Notice of Meeting Polk City | Planning and Zoning Commission (P&Z) *********

May 17, 2021 | 6:00 pm City Hall | Electronic Meeting **Due to Covid-19 the P&Z Commission will meet in person with Public Meeting participation via phone only Call in local 515-329-8019 Participant Code 593054 Public can provide comments directly to support**

PRELIMINARY PLAT REVIEW

Date:May 14, 2021Project:Big Creek Commons

PRELIMINARY PLAT BIG CREEK COMMONS PLAT | 400 EAST VISTA LAKE AVENUE POLK CITY, IOWA

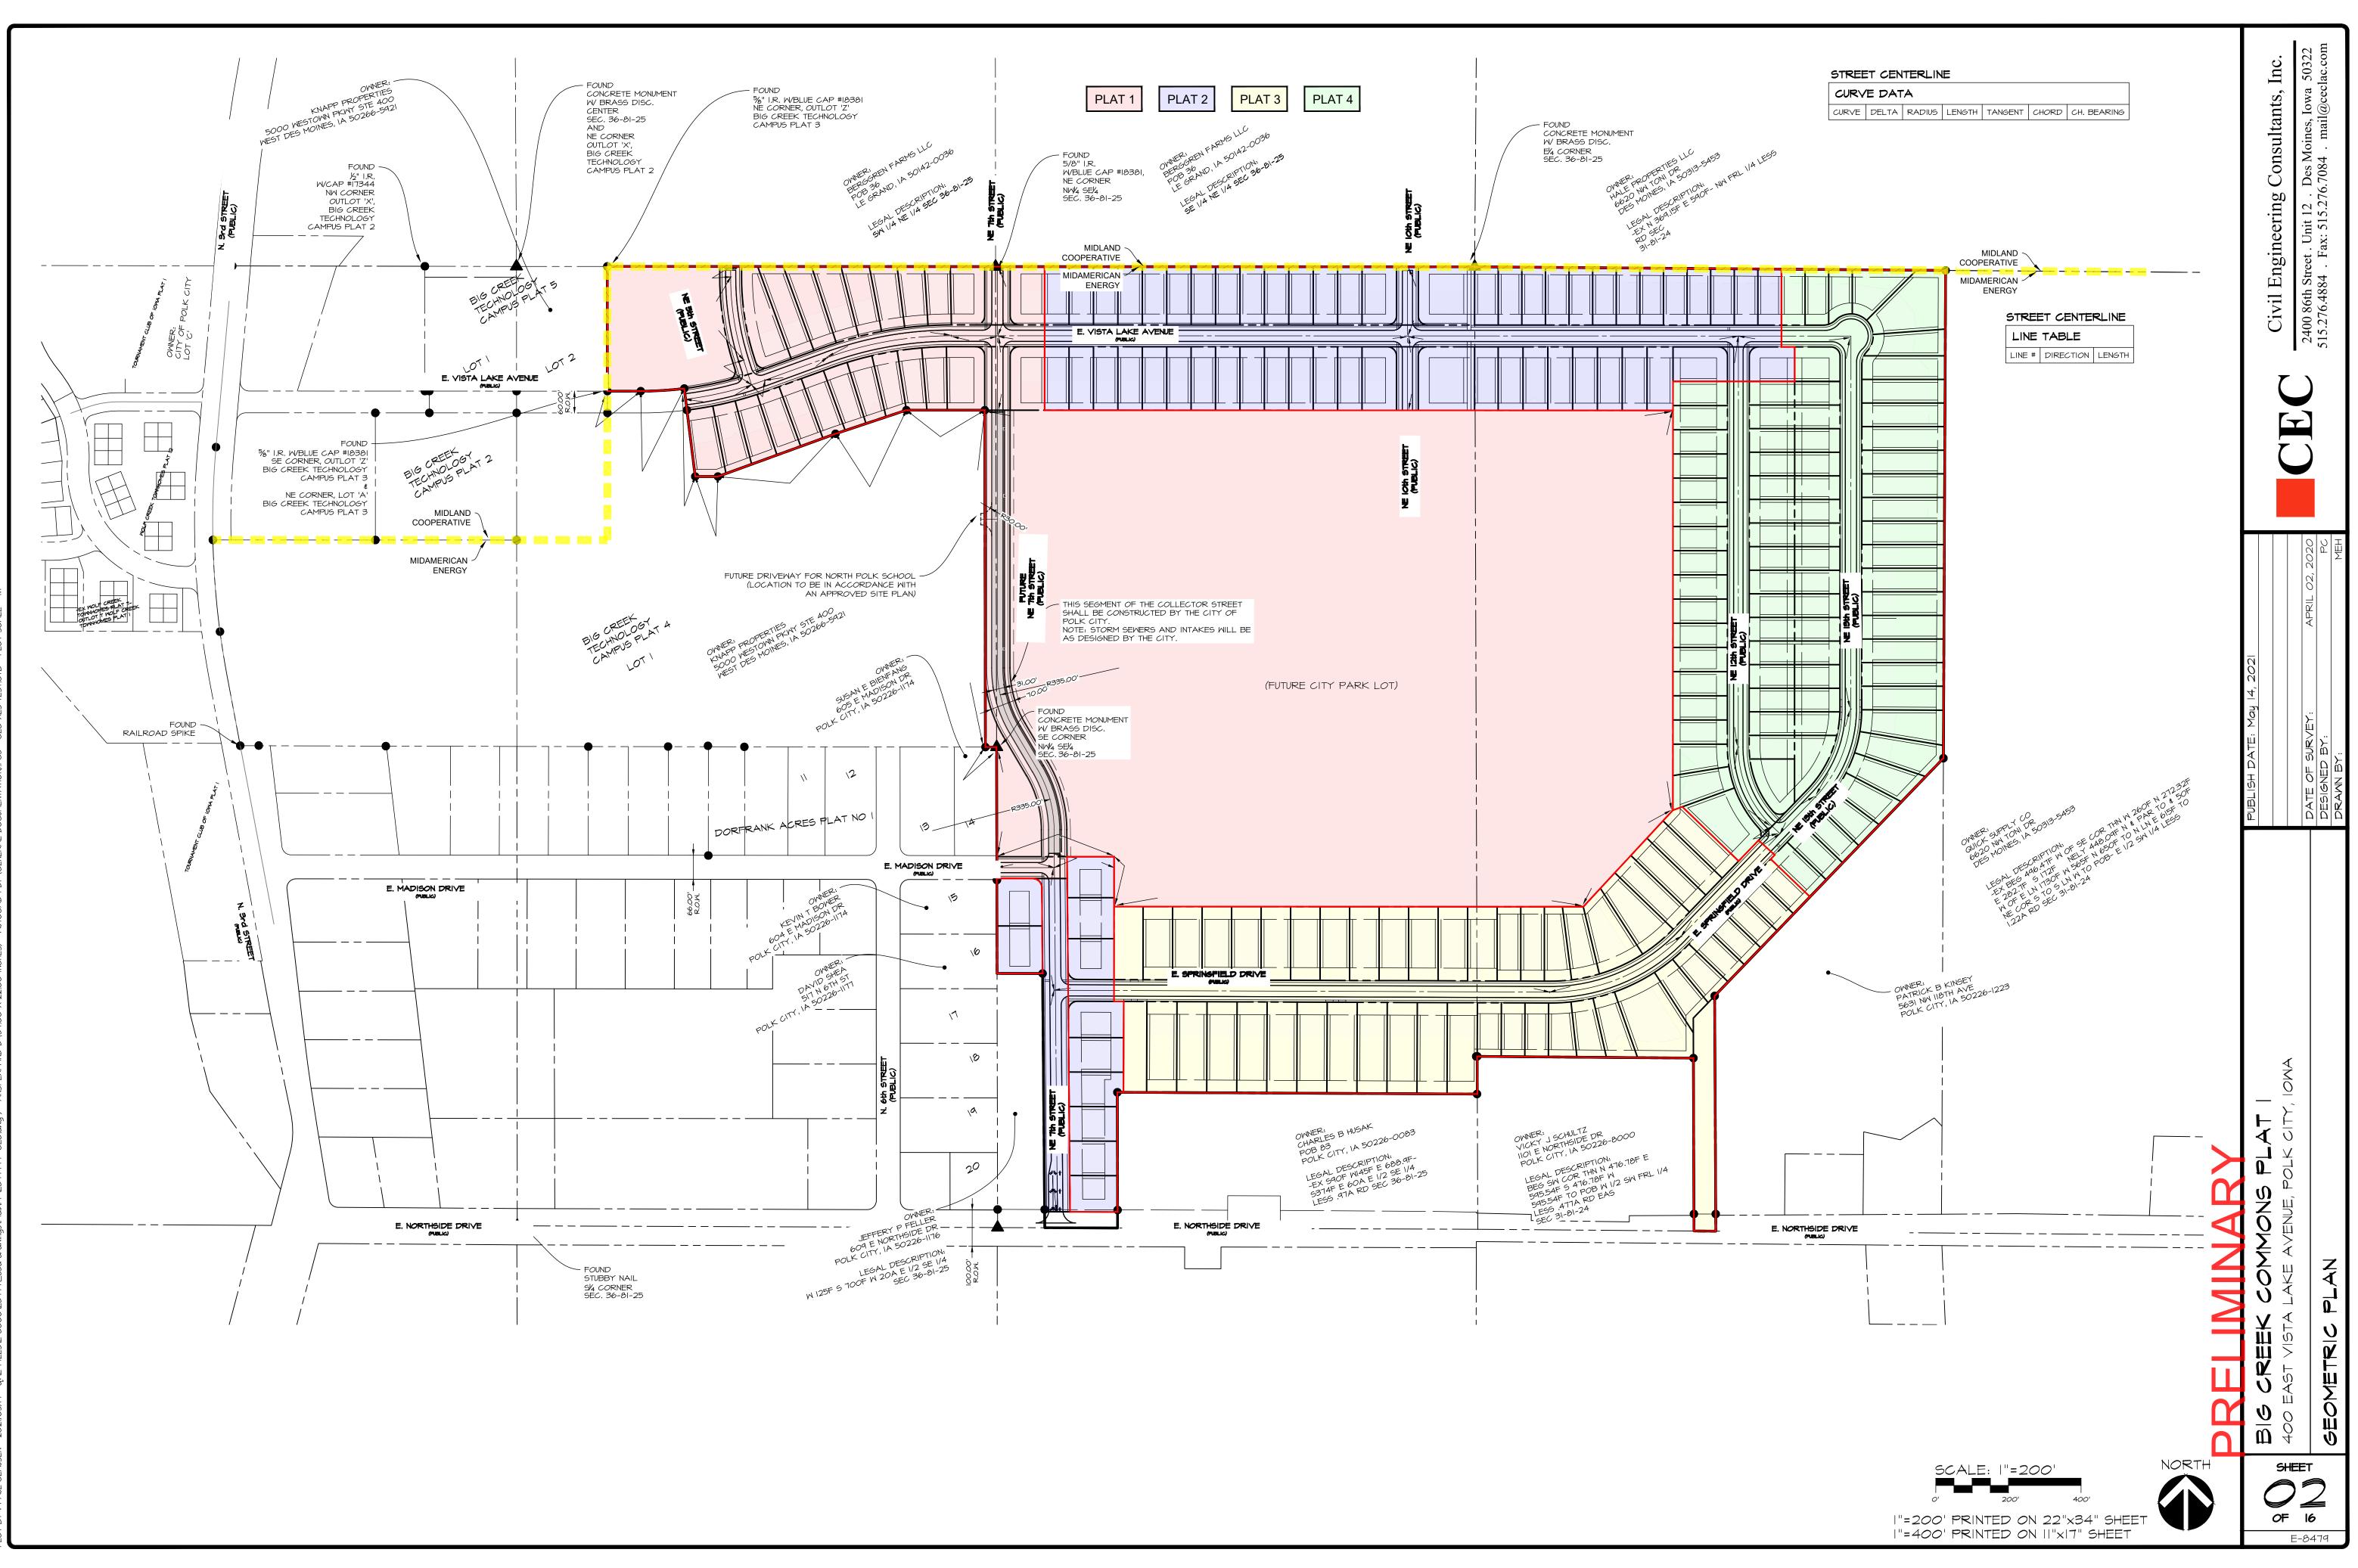
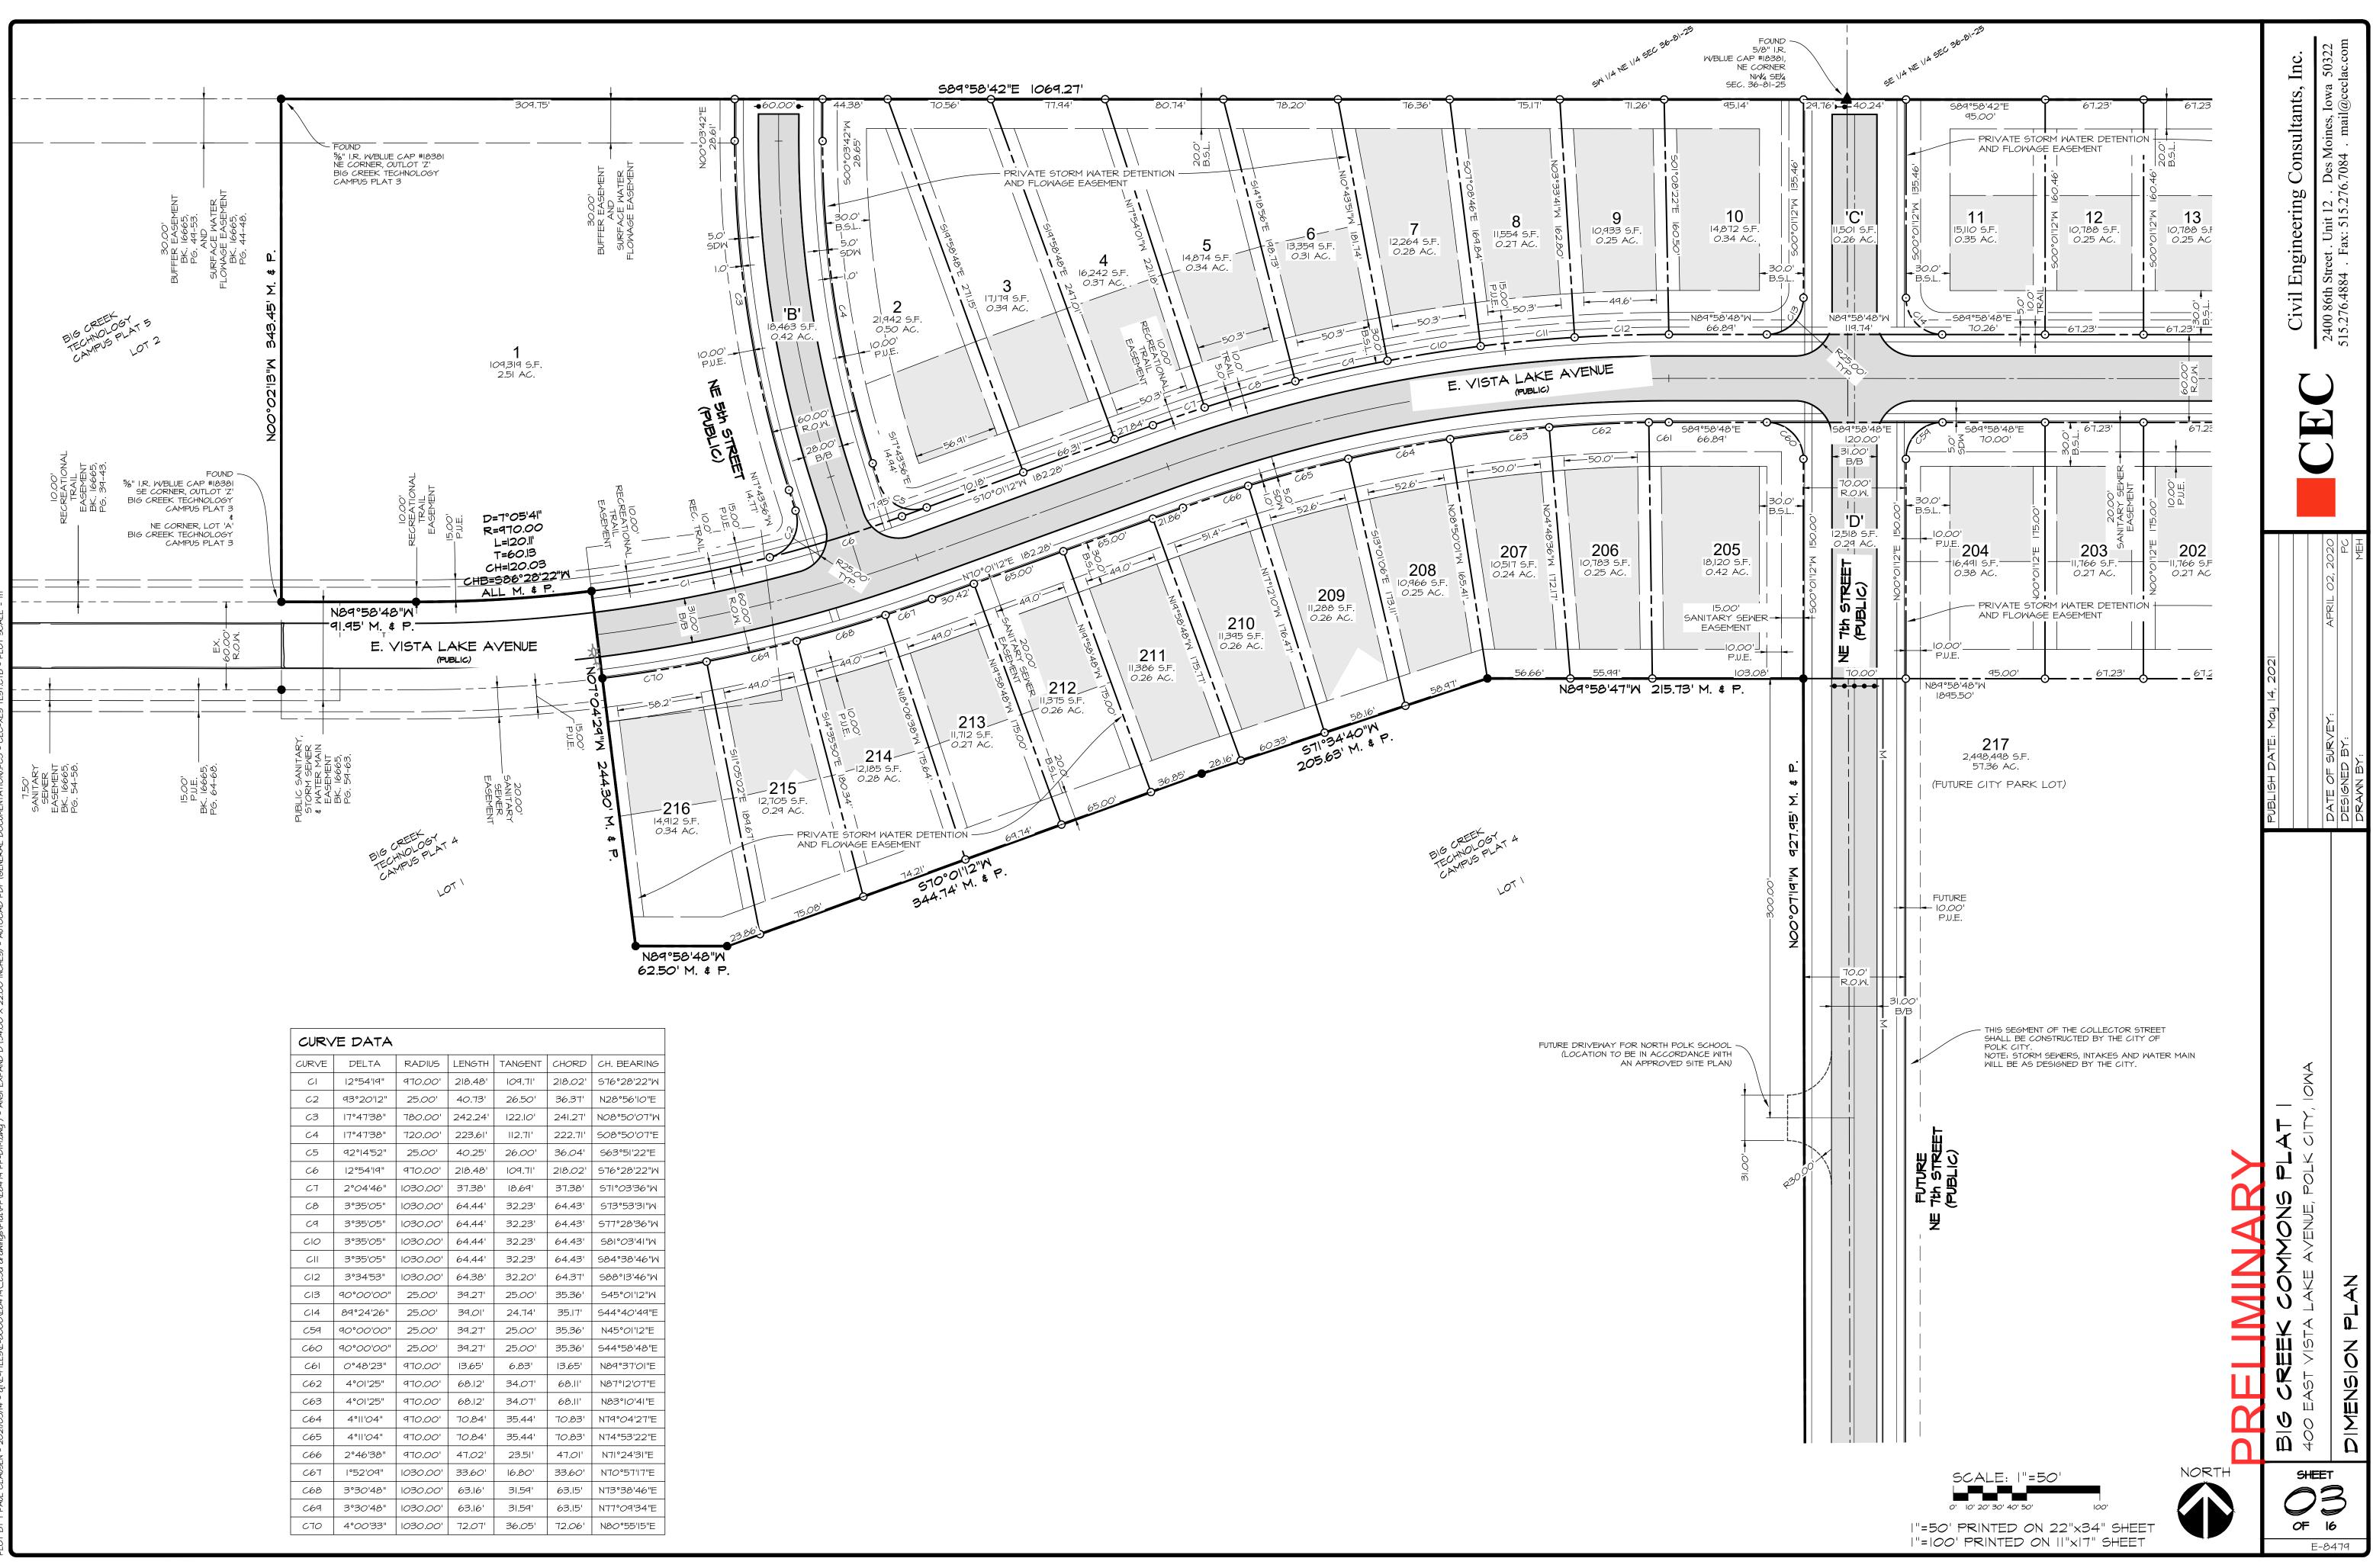
Pursuant to our review of Submittal #3, based on the Preliminary Plat, we offer the following preliminary comments.

- 1. The 10' wide trail on the north side of E. Vista Lake should be shown entirely within the 10' wide recreational trail easement rather than partially within the public right-of-way. If Council approves the elimination of the trail on the north side of E. Vista Lake Avenue, show a 5' wide public sidewalk easement in its place and show a 5' public sidewalk entirely within this easement.

- 2. Show the existing sanitary sewer easement on the south side of the plat, including book and page, and label the portion of this easement to be vacated prior to final plat approval. Show and label a proposed sanitary sewer easement on the south side of Lot 99, based on the depth of the sanitary sewer. Label the pipe as an 8" sanitary sewer.

- 3. On the future construction drawings, the sanitary sewers along the east NE 7th Street will require the developer to obtain sanitary sewer easements from the school. Alternatively, these sanitary sewers will need to be relocated such that an easement is not necessary.

- 4. It appears the layer with street grade labels and sanitary sewer slopes was turned off.
- 5. Provide a revised Storm Water Management concept addressing prior comments including updated summary table to compare pre- and post- runoff at each discharge point, updated drainage area maps with all discharge points labeled.

- 6. Revise Note #19 to refer to the construction drawings for Big Creek Commons Plat 2. Revise Note #20 to refer to Outlot X rather than Outlot V and should state the "trail easement on Outlot X will be dedicated with Plat 3 or upon the request of the City of Polk City at the time of trail construction, whichever comes sooner."
